1601 LeMoyne Ave Cuse Car Care, LLC project roadmap

<i>R-24-26</i>	<i>Staff Report – July 8, 2024</i>
<i>Application Type:</i>	Resubdivision
<i>Project Address:</i>	1601 Lemoyne Avenue (Tax Map ID: 004.-05-03.0), 1611 Lemoyne Avenue To City Line, (Tax Map ID: 004.-05-02.0), 1585 Lemoyne Avenue (Tax Map ID: 004.-05-04.1)
<i>Summary of Proposed Action:</i>	<p>The Applicant proposes to merge three lots (1601 Lemoyne Ave, 1611 Lemoyne Ave, and 1585 Lemoyne Ave) into one new lot. The parcels are also across with municipal boundary in the Town of Salina.</p> <p>The applicant intends to build a two-story addition to the existing 1 story car repair shop upon the approval of resubdivision</p> <p>New lot 4A (only the portion in the City of Syracuse): 0.57 Acres/25,003 SF</p>
<i>Owner/Applicant</i>	Michael Pierce, Cuse Car Care LLC (Owner) Jared McCormick, Daniel Manning-Architect, PLLC (Applicant)
<i>Existing Zone District:</i>	Mixed-Use Transition, MX-3 Zone District

<u>SP-24-09</u>	Staff Report – July 8, 2024
Application Type:	Special Use Permit
Project Address:	1601 Lemoyne Avenue (Tax Map ID: 004.-05-03.0), 1611 Lemoyne Avenue To City Line, (Tax Map ID: 004.-05-02.0), 1585 Lemoyne Aven

SHEET NUMBER
L-1

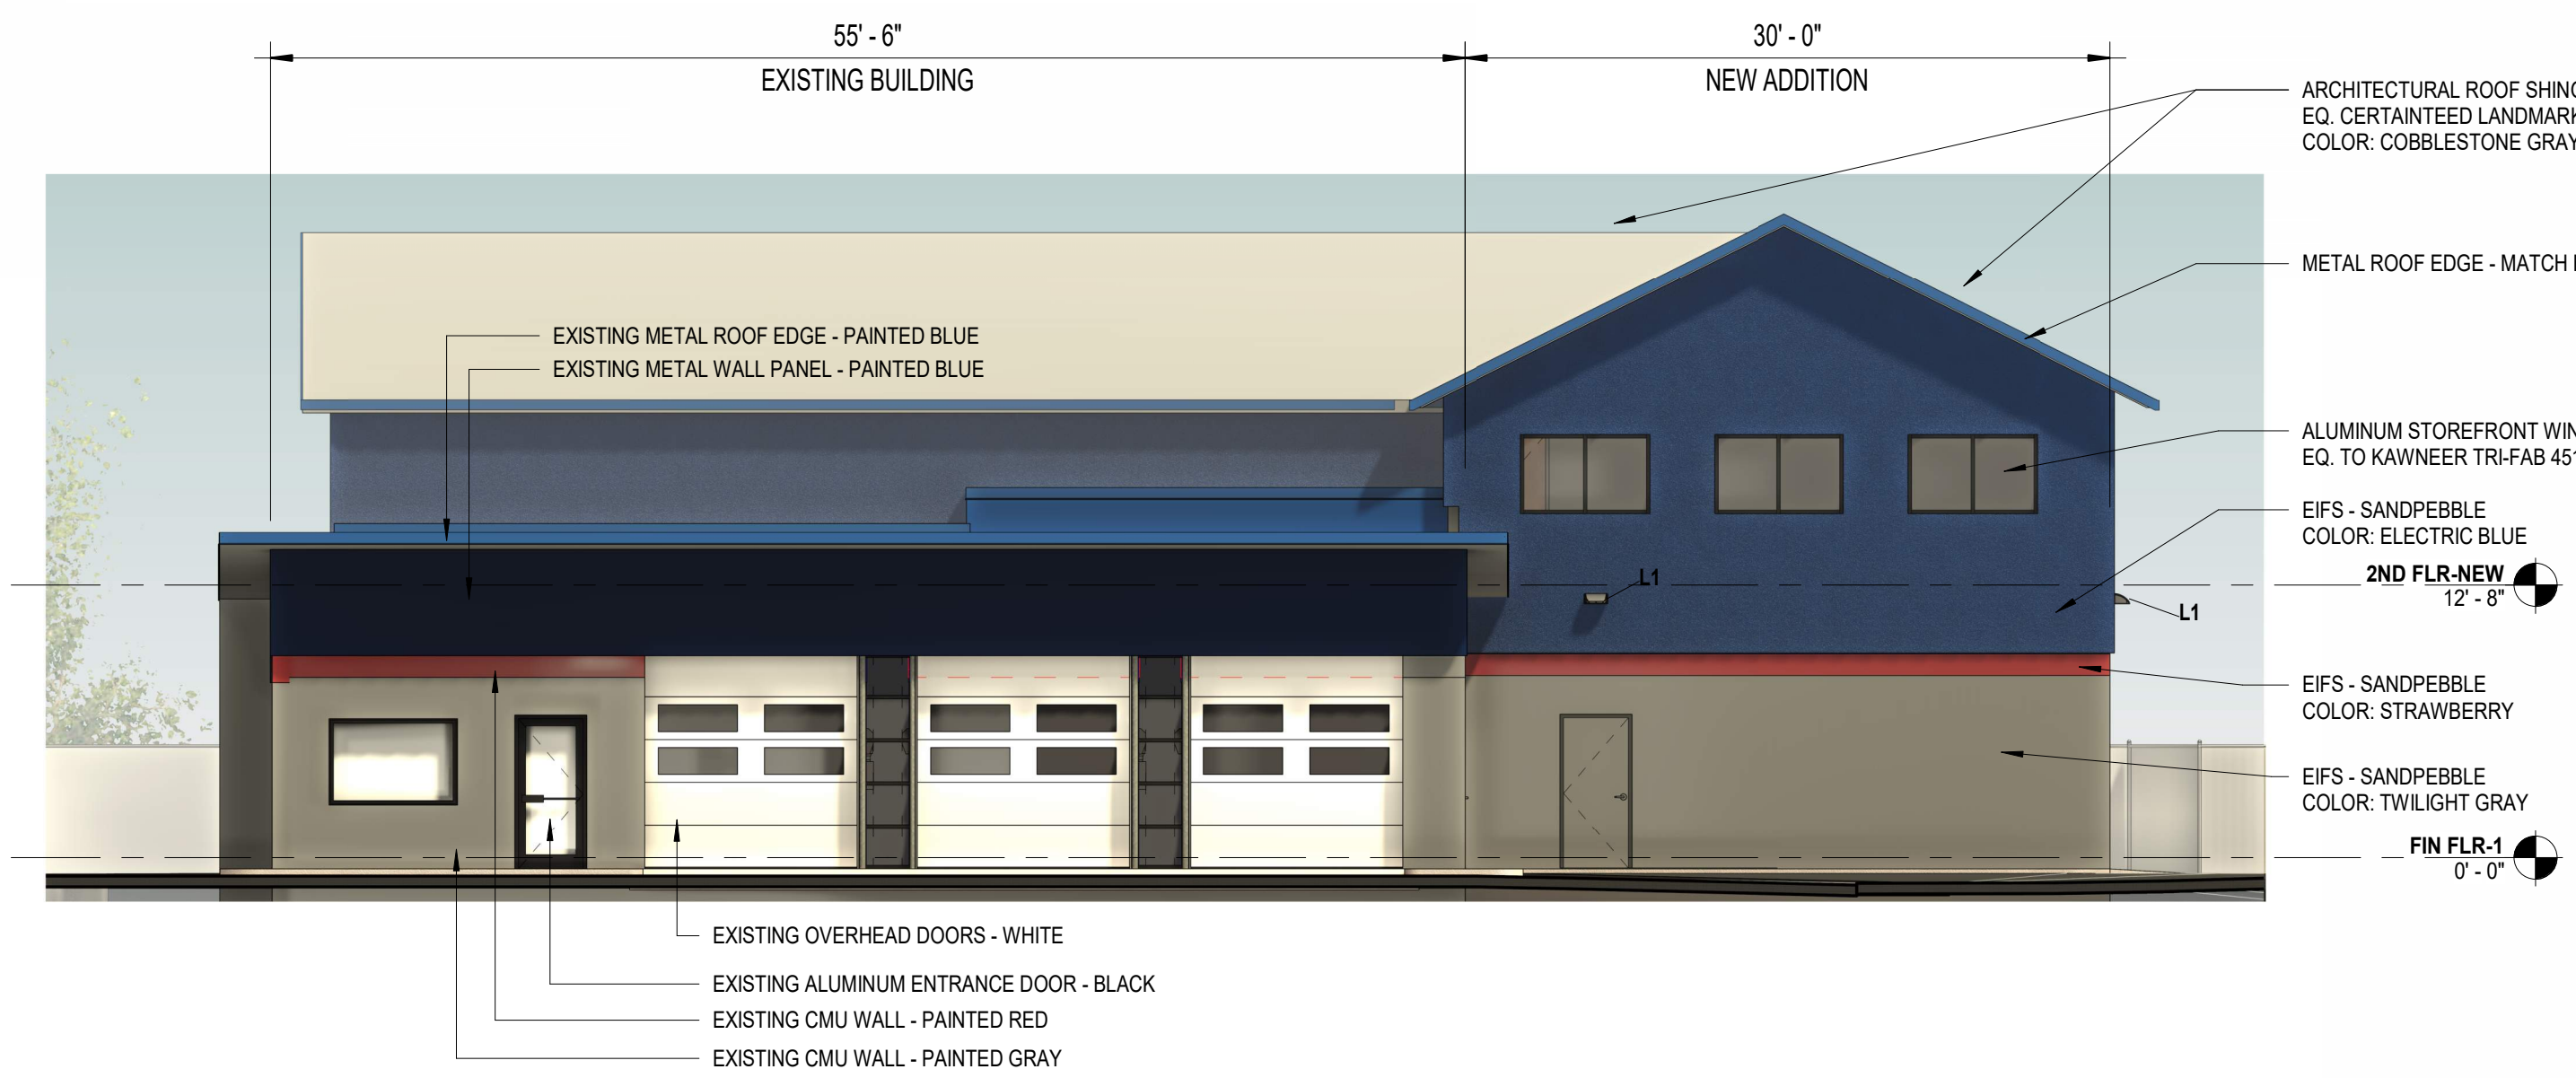
- WHEREAS, per the Site Plans, the applicant is proposing construction of a 2,920 sf 2-story addition to the northeastern and northwestern sides of the existing building which will allow construction of four new service bays in addition to the existing five bays, second floor offices, breakroom, and storage; gravel will be replaced with new asphalt, a dumpster enclosure constructed, and striping of 17 parking spaces along the southwestern and northeastern site boundaries; the Site Plans do not depict any changes in access to the site, plantings, or increase in permeable surface; and

will not result in additional stormwater; the Site Plan depicts 3 catch basins located in the parking lot; and

1. The applicant is required to coordinate with the Onondaga County Department of Transportation regarding access plans and establish formal driveway access to LeMoyne Avenue in conformance with commercial driveway standards. The municipality must ensure any mitigation as may be determined by the Department is reflected on the project plans prior to, or as a condition of, municipal approval.
2. The applicant and City must coordinate a multi-municipal review of the proposed project with the Town of Salina.
3. The applicant and municipality are encouraged to improve appearance of the

site while improving stormwater conditions by adding landscaping and plantings along the road frontage and parcel boundaries, adding bioswales and planting islands, and/or utilizing permeable pavement on site.

1. The applicant is required to coordinate with the Onondaga County Department of Transportation regarding access plans and establish formal driveway access to LeMoyne Avenue in conformance with commercial driveway standards. The municipality must ensure any mitigation as may be determined by the Department is reflected on the project plans prior to, or as a condition of, municipal approval.
2. The applicant and City must coordinate a multi-municipal review of the proposed Site Plan with the Town of Salina.

The applicant and municipality are encouraged to improve appearance of the site while improving stormwater conditions by adding landscaping and plantings along the road frontage and parcel boundaries, adding bioswales and planting islands, and/or utilizing permeable pavement on site.

Approval	Status	Status Date	Reviewer	Comments
DPW - Transportation Planner	Conditionally Approved	06/25/2024	Neil Milcarek-Burke	<p>Revised plans address previous comments.</p> <ul style="list-style-type: none"> - Applicant to ensure that cross access with neighboring parcels is restricted unless agreement in place, and parking areas along southern property line incorporate bollards or other fixed objects (no wheel stops) to prevent parking on grass. <p>Revised plans required. Current site is hazardous to pedestrians and other traveling public due to lack of channelization for vehicle ingress/egress at a high-volume signalized intersection of an Arterial and Major Collector.</p> <ul style="list-style-type: none"> - Parcel to conform to 24' max width curb-cut, current site plan shows ~120' feet total curb-cut. All other areas outside typical 24' opening to be restored to full reveal granite curb. - Concrete sidewalk required required across Lemoyne Ave frontage, including across driveway. Walk to be located at property line. - Asphalt is not a permissible ground cover material in the ROW, all asphalt in the ROW is to be removed and area restored to topsoil & grass, outside of revised driveway opening. Area between sidewalk and curbline should be grass, and incorporate any requirements per Forestry Department. - Parking area/lot frontage to incorporate a guide rail or other fixed vertical objects (no wheel stops), other than

- Parking area to be curbed/incorporate fixed vertical objects (no wheel stops) along all sides.
- Parking area to incorporate greenspace buffer, 5' or greater along entirety of Lemoyne ave frontage outside of driveway opening, measured inwards from property line. To include perirenal plant material/trees/etc.
- Planting plan required, grading/drainage plan may impact/increase buffer requirements.
- ADA compliant walkway to/from the main entrance and public ROW/sidewalk required, typically aligned with loading area of accessible parking stalls.

DPW - Sanitation & Sewers	On Hold	04/17/2024	Vinny Esposito	<p>please provide a drainage plan, The site will be nearly 100% impervious as per plan. Storm water must be mediated to an extent, dry wells or re-charge trenches. Also the sewer in the 20' ROW must be located precisely as I believe this is a 30" storm sewer.</p>
DPW - Traffic Control	Conditionally	04/23/2024	Charles	4.23.24 Conditionally Approved.

Approved		Gafrancesco	No sidewalk closures or obstructions or road or lane closures will be allowed as part of this work unless accompanied by MUTCD compliant detour.
Zoning Planner	On Hold	04/17/2024	Haohui Pan	Updated plan needs: The east side of the building that abutting the adjacent Residential Zone shall be fenced.
Engineering - Stormwater (SWPPP)	Conditionally Approved	04/25/2024	Mirza Malkoc	<ul style="list-style-type: none"> • All construction in the R.O.W. will require a road cut permit, all construction in the R.O.W. to be per City standards and specifications. • Complete set of the stamped engineering site plans with specific details are required to complete a detailed project permit review. • Designer shall clearly indicate on the site plans how much soil disturbance this project will create. If the soil disturbance is over 10,000sf then a SWPPP is required but if the soil disturbance is less than 10,000sf then the designer need to do some improvements to the site by capturing the stormwater sheet flow and treating it before discharging it to the City's ROW. • Proposed grading shall be graded to prevent stormwater sheet flow to adjoining properties & to the City R.O.W. • The Project is subject to Onondaga County's 1:1 offset. The City requires an offset plan & details for review. Applicant shall submit sanitary flow data to the Engineering Department, the determined offset plan then most likely will require Common Council Approval. • Onondaga County Plumbing Control shall review and approve the plans as well.
